## Indoor Station Firmware V2.2.8\_build230219

### Release Note (2023-03-02)

Device Model	DS-KH8350-WTE1, DS-KH8350-TE1, DS-KH6320-WTE1, DS-KH6320Y-WTE2, DS-KH6320-WTE2(B), DS-KH6320-TE1, DS-KH8520-WTE1
Firmware Version	V2.2.8_build230219
iVMS-4200	V3.8.3.1 or later

**B. Link indoor station with main and sub door station**

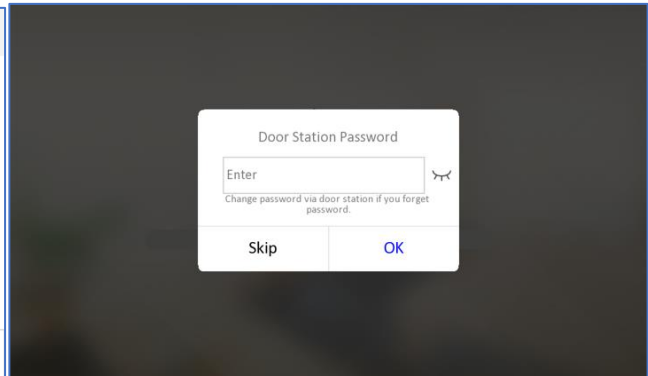
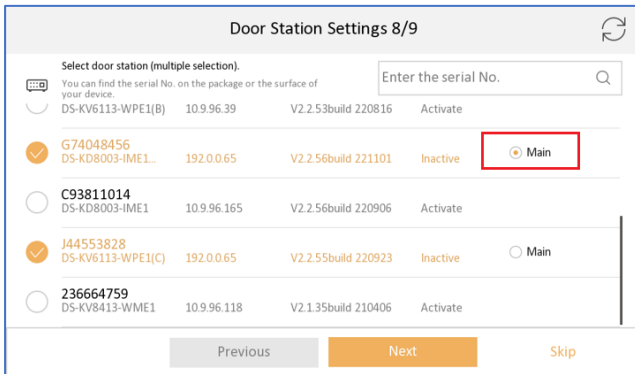
- a. the first selected will be the main door station by default, the second will be sub1, 3<sup>rd</sup> will be sub2, etc. You can also cancel and select the main door station manually.
- b. Maximum select 17 door stations at one time (1 main and 16 sub door stations)
- c. If the selected devices are not activated, indoor station will activate them with same activation and registration password, then set the IP address for them in same network segment automatically.
- d. If the door station is already activated with different password, it will prompt you to input door station password
- e. If the main and sub door station are activated with different activation password, the registration will be failed (sub door station can't call indoor station).

**C. Link indoor station with indoor extension**

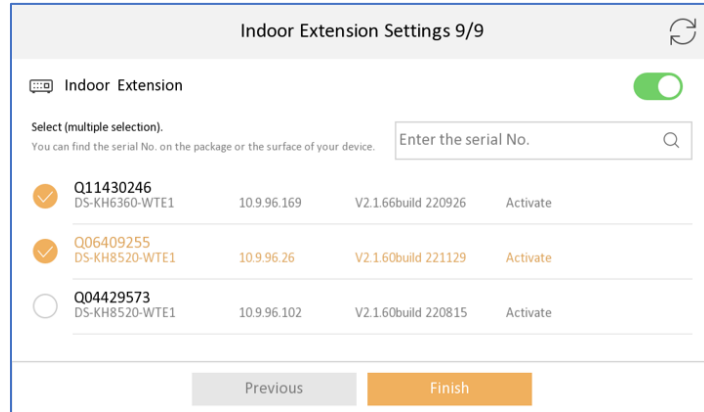
- a. The selected indoor station will be and numbered as indoor extension 1,2,3...
- b. Maximum select 5 indoor extensions at one time
- c. If the selected devices are not activated, indoor station will activate them with same activation and registration password, then set the IP address for them in same network segment automatically.
- d. If the selected devices are activated with different password, the registration will be failed (door station can't call indoor extension).

D. Pairing with main door station, sub door station and indoor extension

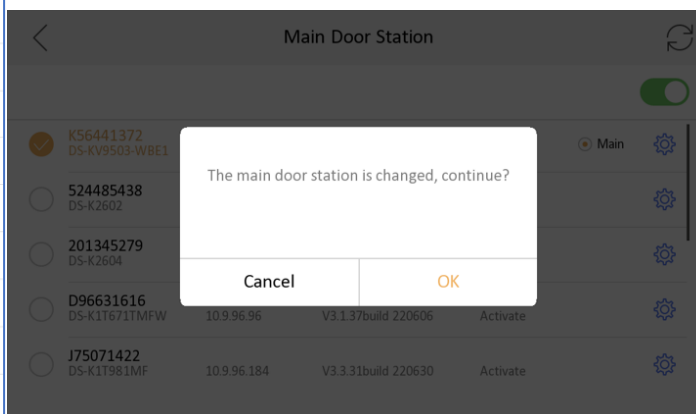
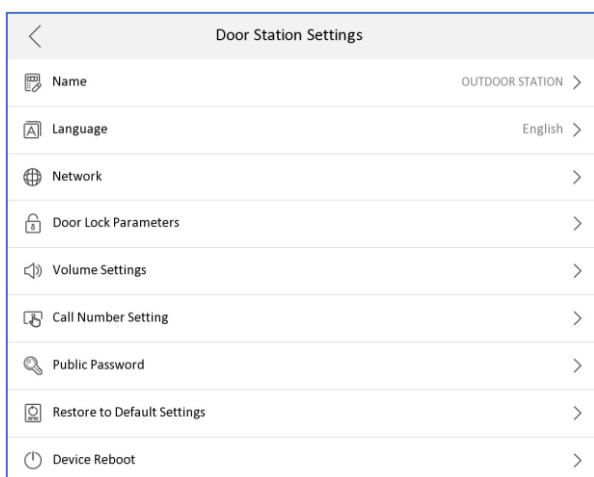
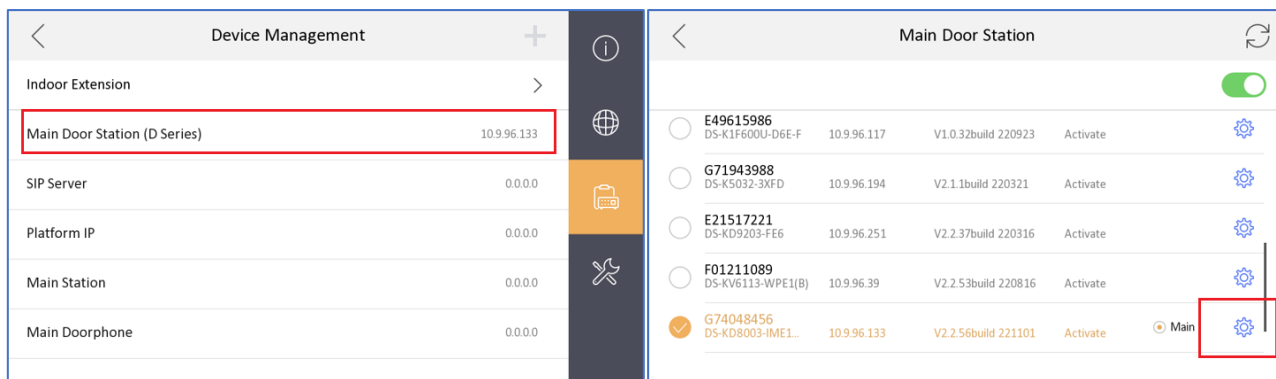
*Note: The pairing time duration depends on the device quantity you selected in previous steps, it will take about up to 5 mins, please wait patiently until the process finish and show “Configured” as below.*

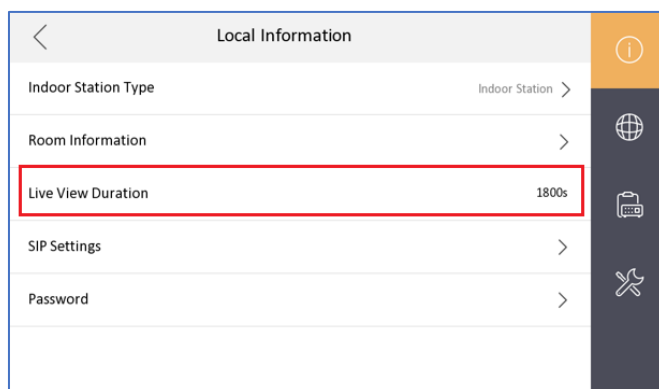
1. Optimized the icon of door station registration status in the main UI up right corner.

*Note: If the door station call indoor station failed, you can click this icon  to register to door station manually, if register failed, it will indicate the reason for the failure.*

Before	Now
Indoor station registers to door station success		
Indoor station registers to door station failed		
Indoor station registers to door station and KM9503 success

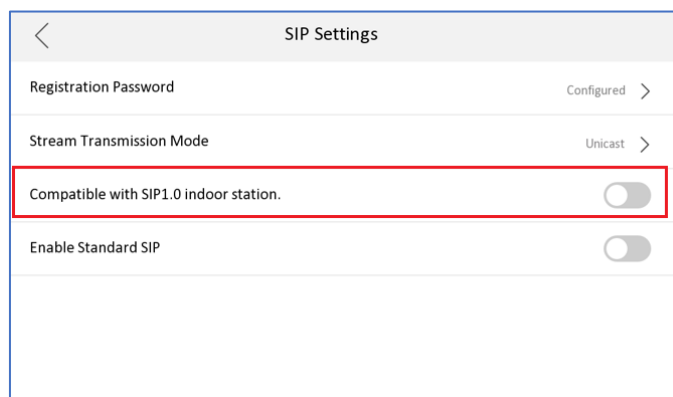
3. Support switching between protocol 1.0 and 2.0, by default it's protocol 2.0  
After enable, the indoor station is compatible with protocol 1.0 indoor extension and not

compatible with protocol 2.0 indoor extension.

*Note: After enable, all indoor extension of this indoor station must be protocol 1.0 firmware, don't mix protocol 1.0 and 2.0 indoor extension under same indoor station, or it will result to calling failed.*

**Wizard-Indoor Station Settings 3/5**

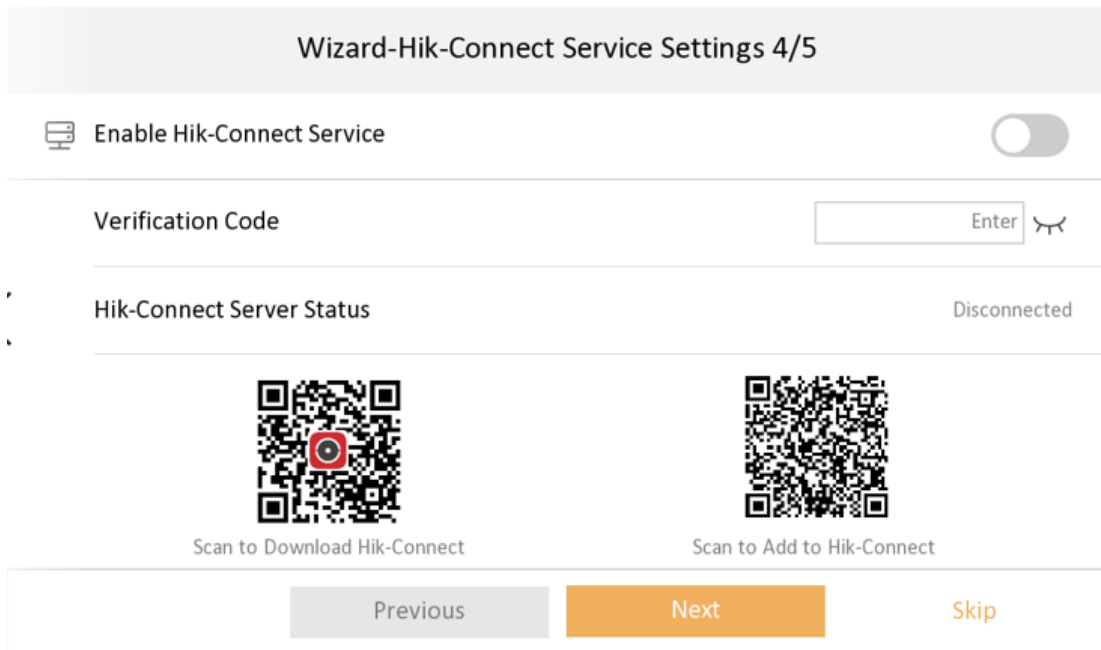
1. Optimize registration password settings in Wizard.

Be consistent with the activation password.  
When enabled, the people who has the registration password will have the device admin permissions.

**Wizard-Hik-Connect Service Settings 4/5**

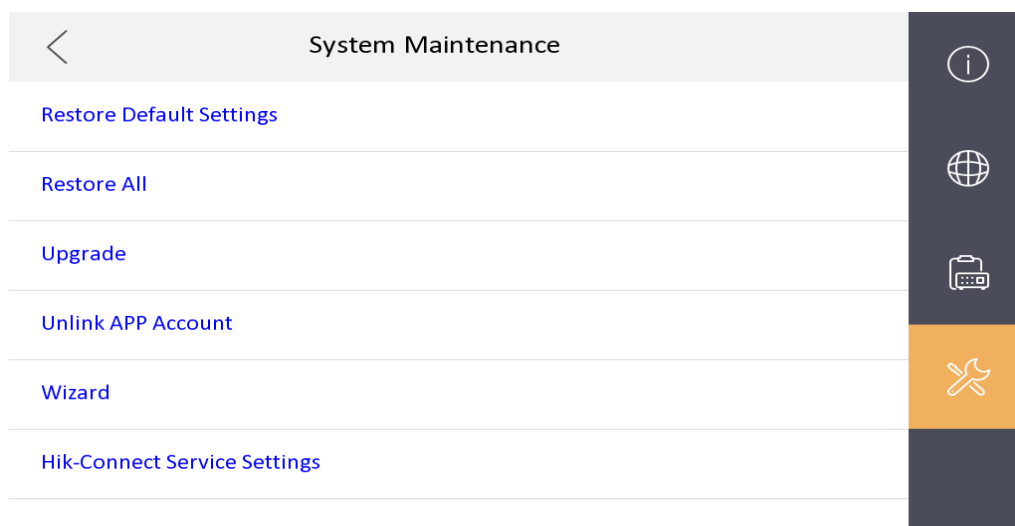
1. Verification code is empty by default.

**Add Device**

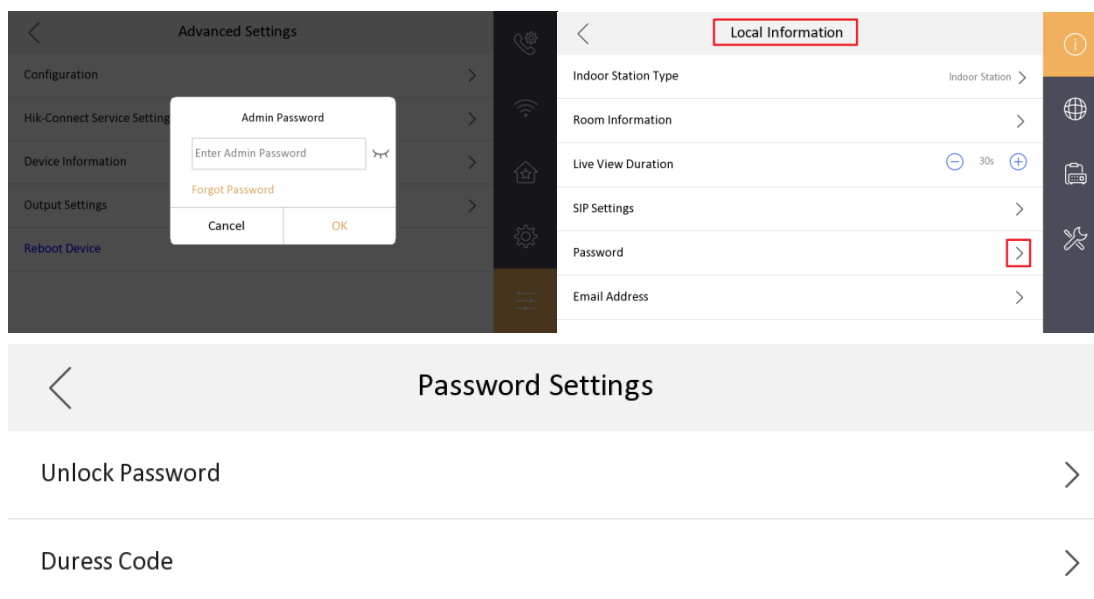
4. Add IPC interface, when Open Network Video Intercom protocol is selected, add plaintext ciphertext switch menu item configuration

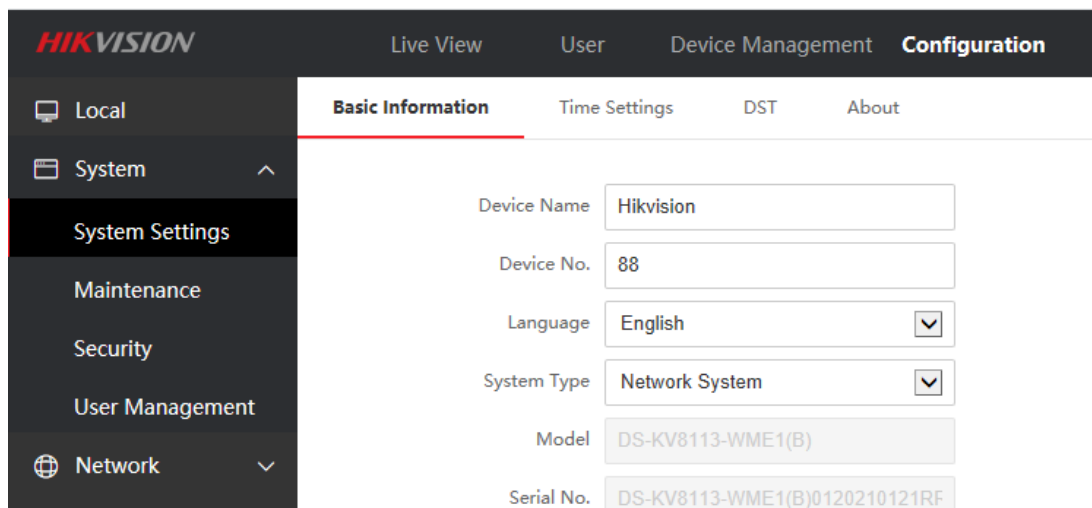
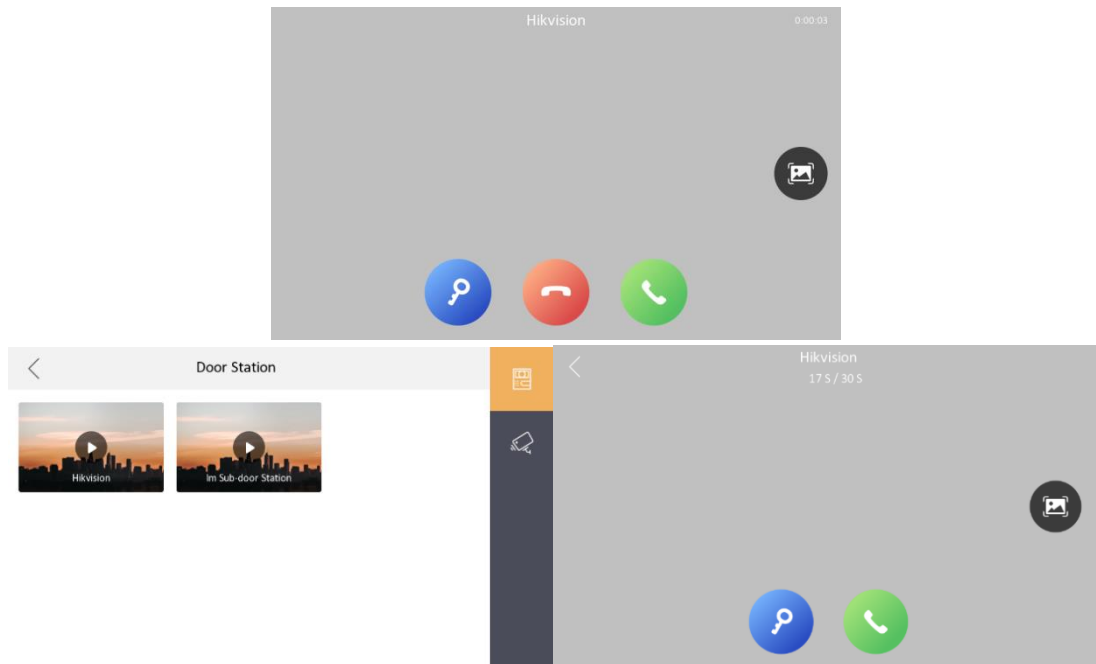
1. Change the position of unlock password and duress code, to enter the password page requires an admin (activation) password.
